Request	DTC Modification
Project Name	Nashville Yards Parcels 4 & 5
Case Number	2018DTC-009-001
Council District	19 – O’Connell
Requested by	Ragan-Smith Associates, Inc., applicant; Uptown Property Holdings, LLC, owner
Staff Reviewer	Hammer
Staff Recommendation	<i>Approve with conditions</i>

Downtown Code DRC Meeting of 1/3/2019

Figure 4: Section of Upper and Lower 10th Avenue North

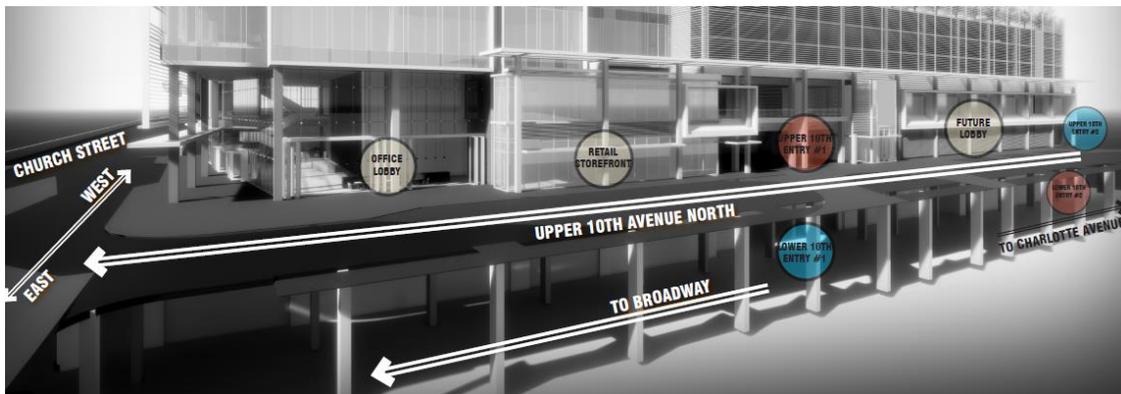
Figure 4, shown above, illustrates how Upper 10th Avenue North fits into the other components of the proposal. Although there is no direct vehicular connection between Upper and Lower 10th Avenue North, the site plan does allow for pedestrian circulation between the two levels. A stairwell, shown in Figure 5 below, built into the new Upper 10th Avenue will allow for direct access for pedestrians without needing to enter the building.

Figure 7: Lower 10th Avenue North Vehicular Entrances

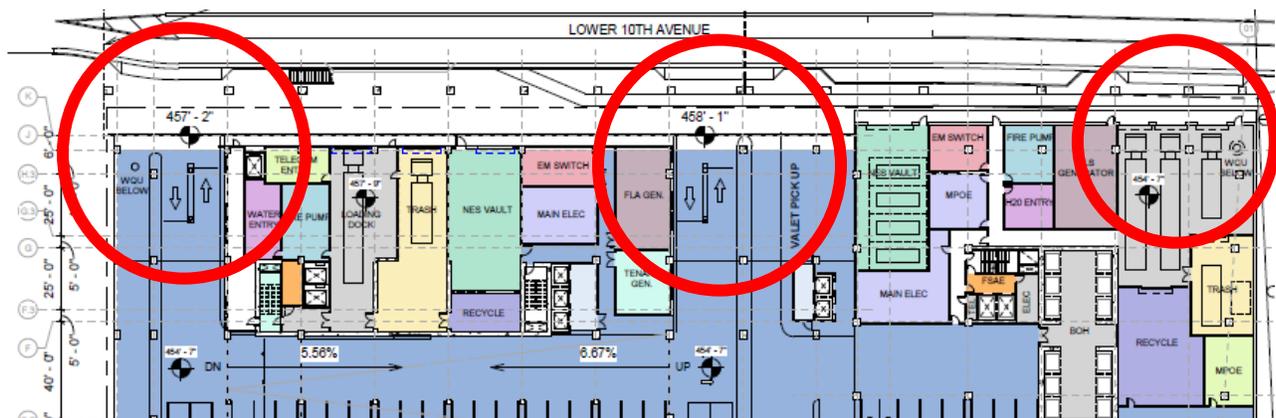
The applicants have requested several entrances to structured parking that exceed the maximum width on the Lower 10th Avenue North frontage measuring 41'-0", 43'-0", and 43'-6", shown below in Figure 7. The entrances of 41'-0" and 43'-0" are entrances for passenger vehicles, whereas the 43'-6" opening is for service vehicles. Due to the presence of Upper 10th Avenue North, Lower 10th Avenue North at this location is anticipated to serve a service and utility purpose, lined with service entrances and access to mechanical elements rather than be lined with active uses. The columns of Upper 10th Avenue North also complicate turning movements and sight distances, making larger entrances warranted. Due to this site condition, staff recommends approval of the modification.

Figure 8: Upper 10th Avenue North Vehicular Entrances

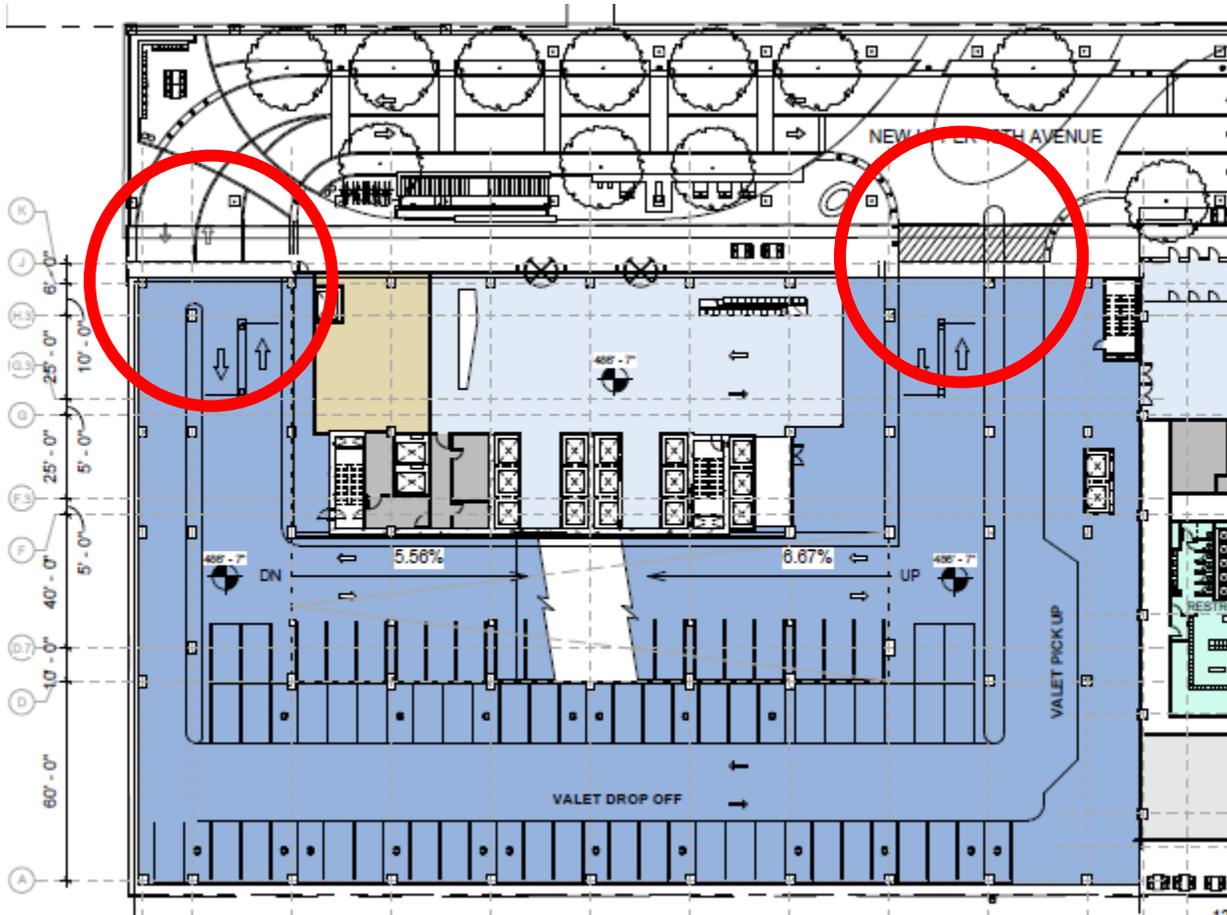
The applicants have also requested two entrances to structured parking that exceed the maximum width on the Upper 10th Avenue North frontage measuring 42'-6" and 44'-0", shown in Figure 8 below. Upper 10th Avenue North is, in essence, a private street that terminates at the northernmost property line of the subject property, meaning that vehicular traffic must proceed through the

building to return to the intersection of Upper 10th Avenue North and Church Street. Due to this atypical elevated street, entrances are three lanes wide. The site is large enough to devote a large portion of the building's footprint to internal drop-off areas, valet services, and parking areas. To mitigate the effect of this request, the applicants are proposing a pedestrian refuge island for the opening of 44'-0". As Upper 10th Avenue North terminates adjacent to the opening of 42'-6", the sidewalk corridor at terminates as well, making the intent of the standard not applicable. For these reasons, staff recommends approval of this modification.

All vehicular accesses will be required to comply with all other standards of the Parking and Access section, including utilizing protective devices, like bollards, and clearly indicating the distinction between vehicular lanes and pedestrian areas through changes in grade, color, texture or material.
